Job Name: Westgate Community Center

Re: Westgate Community Center: M09D030
COA Hydrology Site Plan for Building Permit Approval Re-Submittal

DRAINAGE MANAGEMENT PLAN

SITE DEVELOPMENT PLAN **C-001**

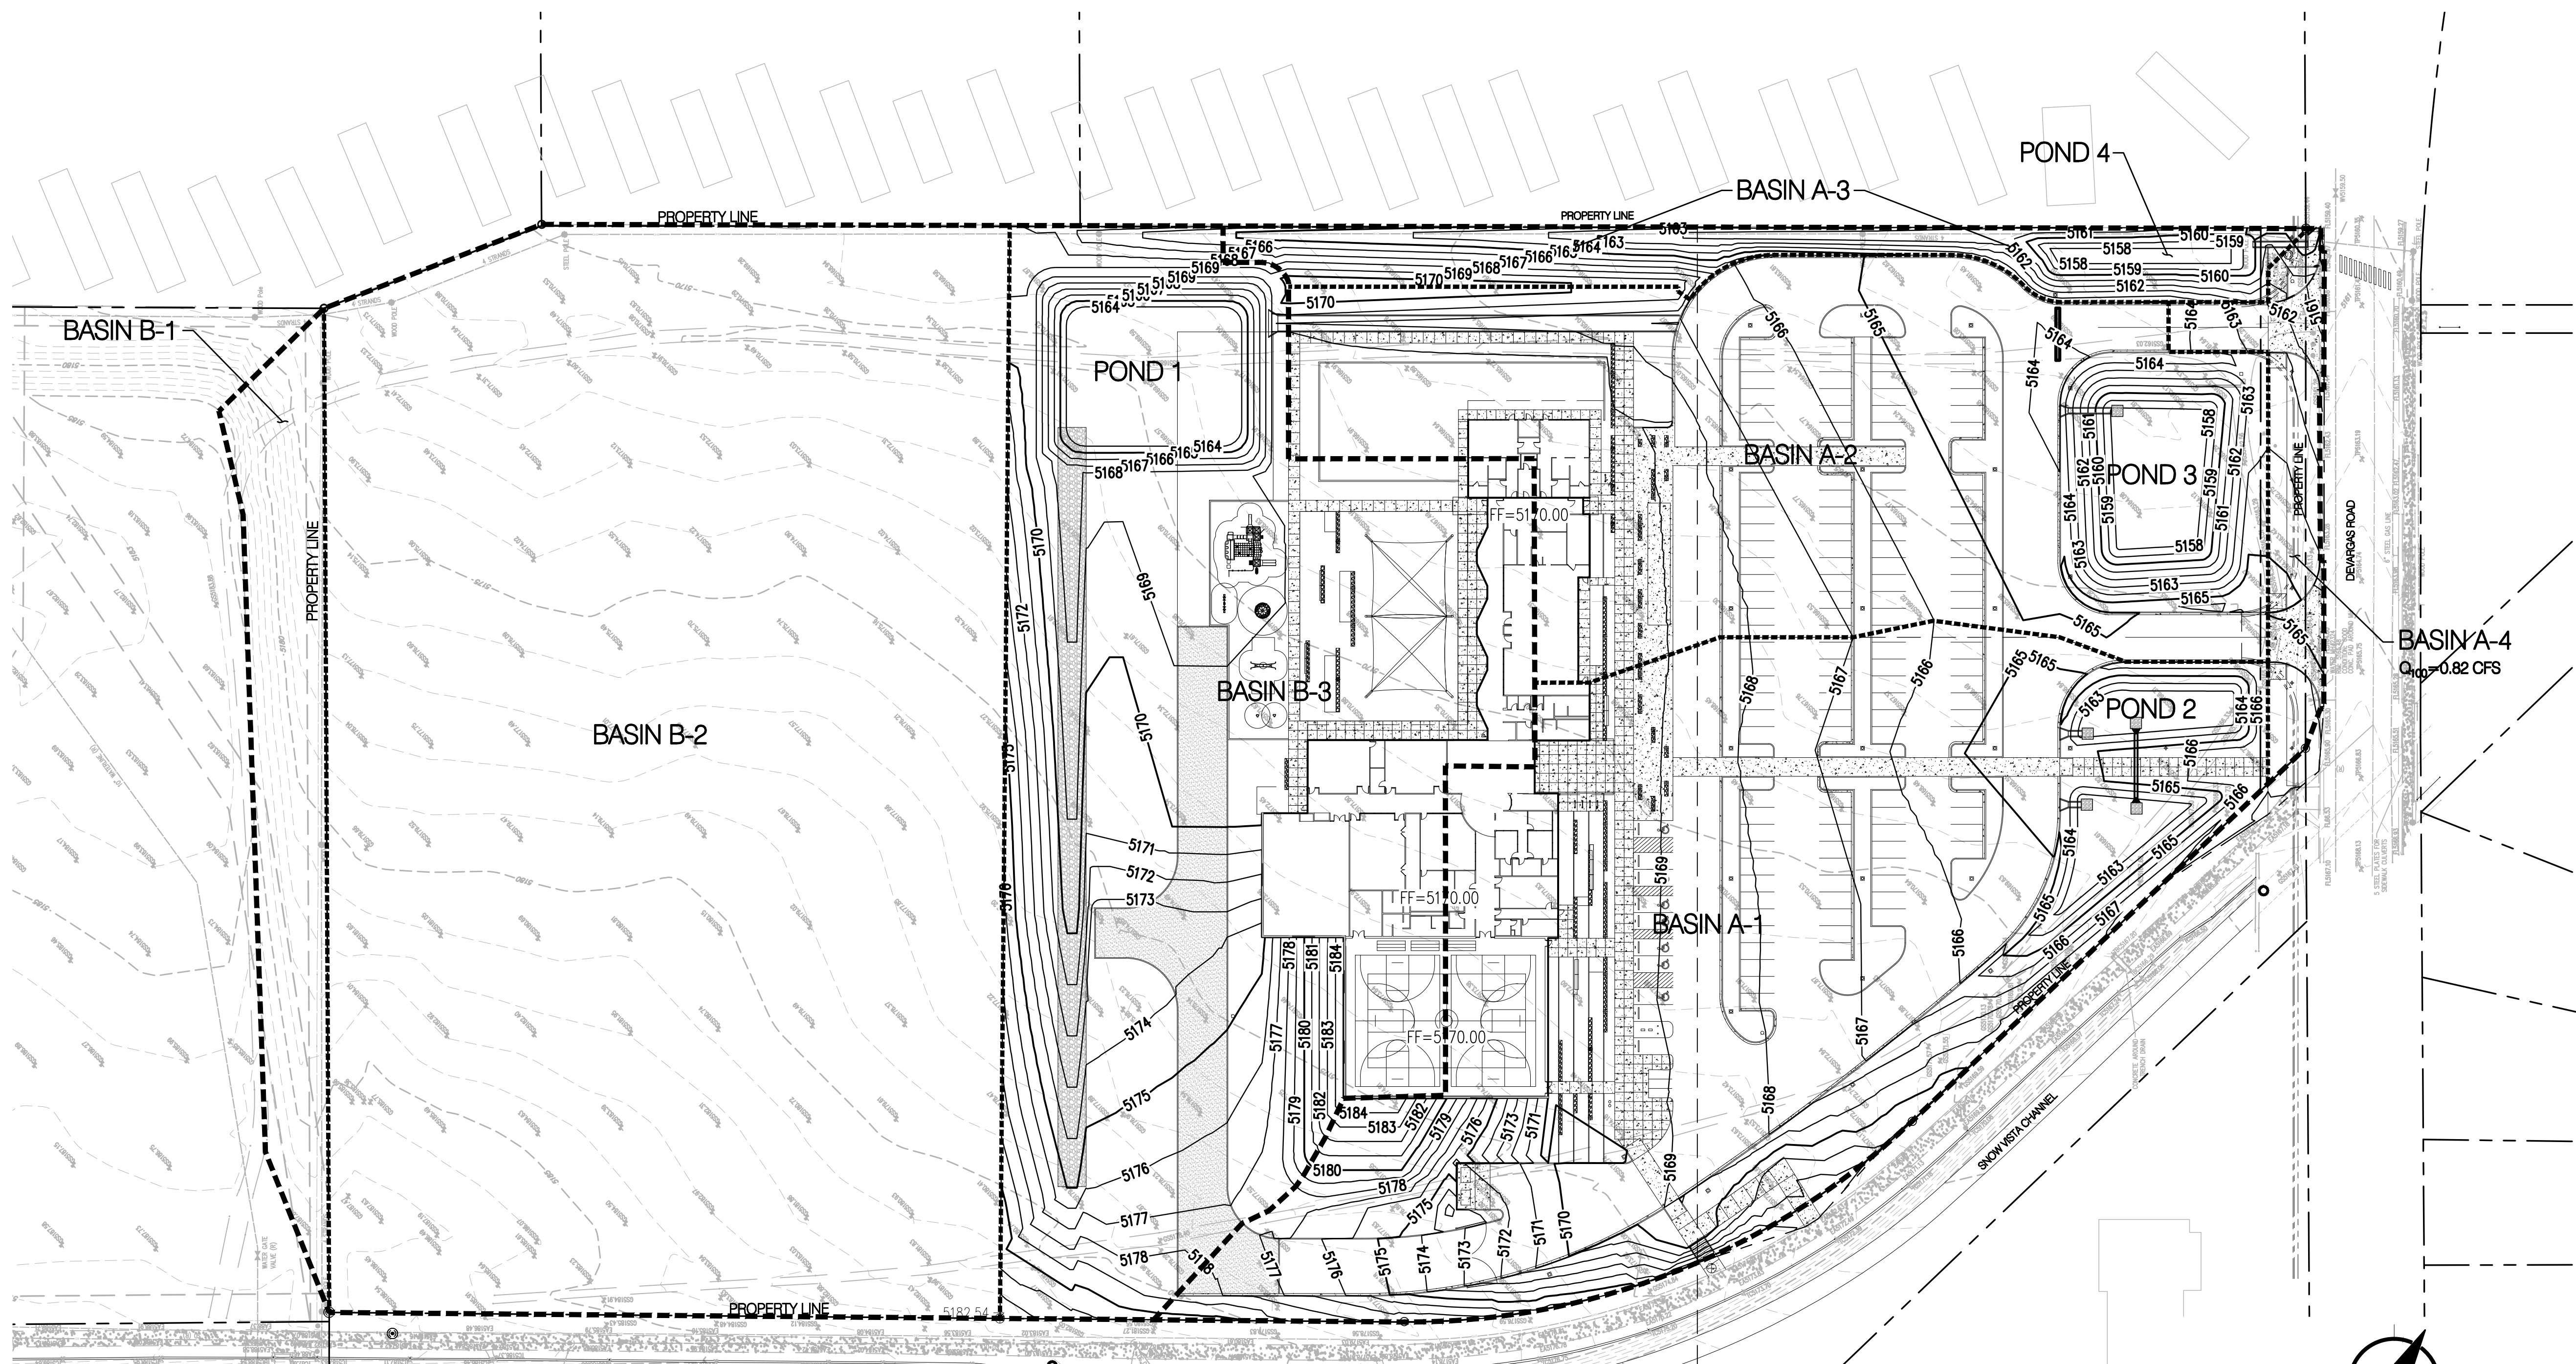
Enclosed for your review is a copy of the Westgate Community Center Drainage Management Plan and Grading Plan. Below is a brief description of how the comments from your response letter (dated 11/21/2018) were addressed:

1. Future public improvements (i.e. new curb & gutter, etc.) are now shown along DeVargas Rd with approximate future spot elevations. The grading has been modified to ensure that at the time these improvements are constructed, the ponds function as originally intended. The Drainage Management Plan shows how Pond 3 varies during proposed and future conditions. Under both conditions, the pond has enough capacity.

2. There is now 1 FT of freeboard within Pond 1. See the Drainage Management Plan for Top of Pond Elevation, Overflow Weir Invert, and Maximum Water Surface Elevation.
The Overflow Weir is now sized for the 100 YR Storm Event. The concrete ribbon channel located to the east of the building is also sized for the 100 YR Storm Event. See the Drainage Management Plan for calculations.
